CCD1: Construction Code Determination Form

Enter short description of Technical Topic (5 words or less): Additional exit stairway below-grade

The project consists of a new high-rise office tower located at 270 Park Avenue in New York, New York that will serve as the new JP Morgan Chase Co. headquarters. The tower will consist of approximately 58 stories and will be approximately 1,388 feet in height. The building is currently being designed in accordance with the 2014 New York City Building Code and will comply with the high-rise provisions of Section BC 403.

ZRD1/CCD1 Response Form

ISSUED FOR
CELLAR EGRESS - GROUND FLOOR PLAN
DRAWN BY
SCALE 1/16" = 1'-0"
DATE FEBRUARY 1, 2020

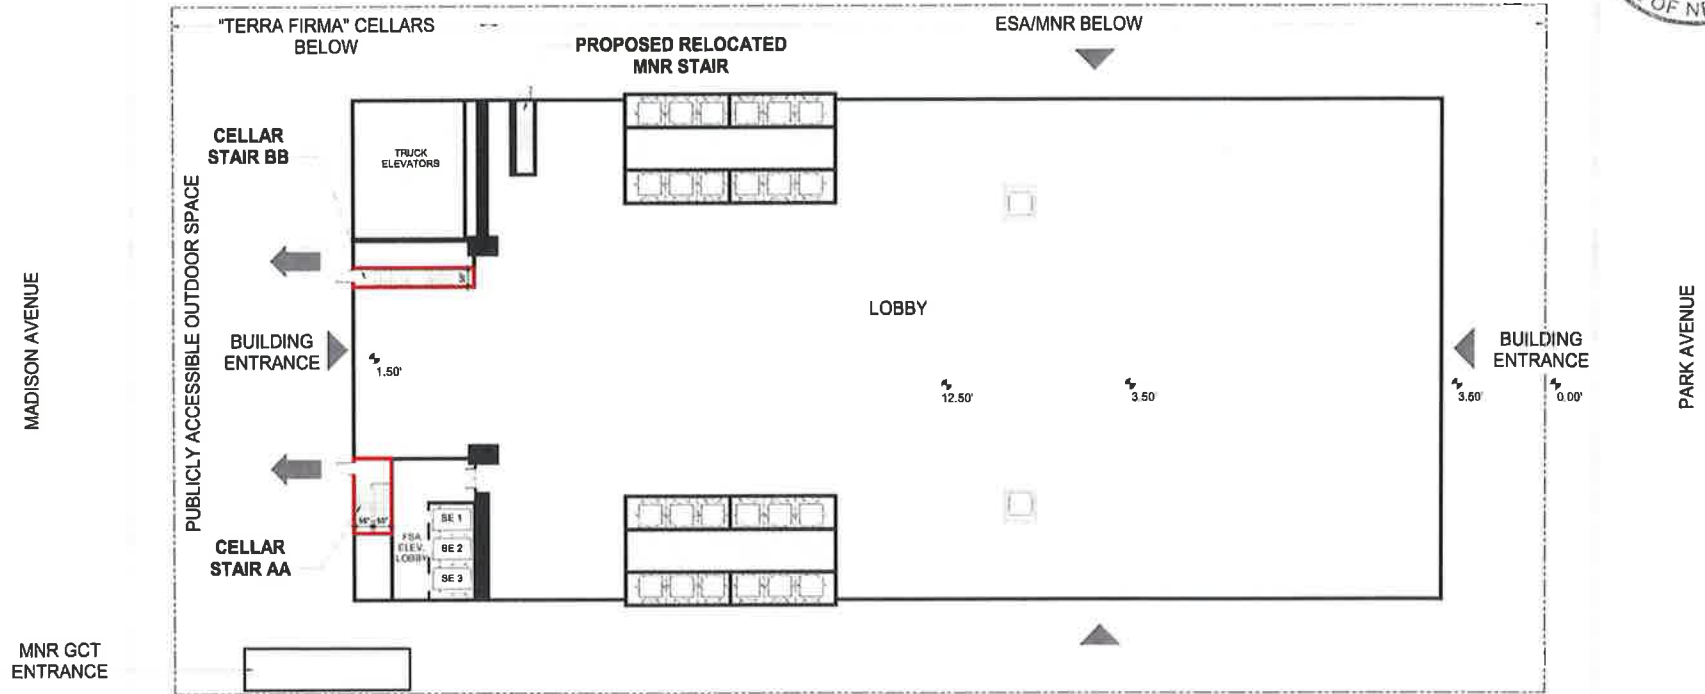
REVISION - STAIRS WIDENED BY 26"

CELLAR EGRESS - CELLAR FLOOR PLAN
SCALE: As Indicated
DATE: FEBRUARY 1, 2020

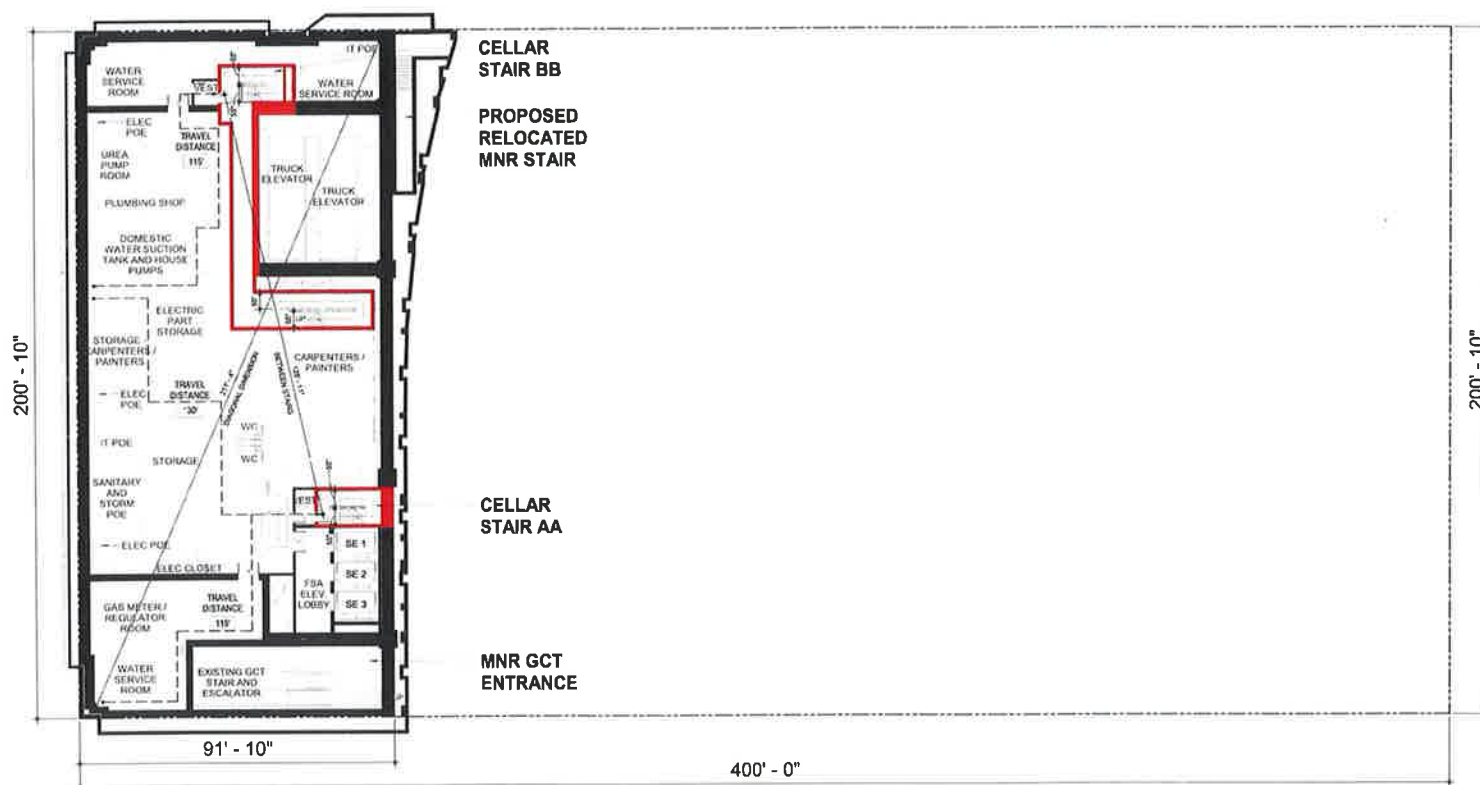
- Site constraints. Providing an additional exit stairway to the below grade portion of the building is a practical difficulty due to the small footprint of terra firma for the site. See the attached floor plans. Of the entire building site of approximately 80,000 square feet, only approximately 20,000 square feet are located on terra firma due to the adjacent MTA trainways.

The locations for below grade building services, including points of entry (POE's) and the loading docks, are very limited. In addition, the below grade levels must accommodate an existing Grand Central Terminal stair and an existing MTA stair, which further limits the available space for an additional exit stairway.

- Plan Examiner to verify a timed egress analysis establishing the egress time it would take for the underground levels evacuation, utilizing the stairs required by 2014 BC 1021.1 and the additional stair that would have been required pursuant to 2014 BC Section 403.5.2. The minimum number of exits required by 2014 BC 1021.1 shall be least 25 percent wider than the exit width required by Chapter 10. The increase in the stair width shall not be utilized in the timed egress analyses.
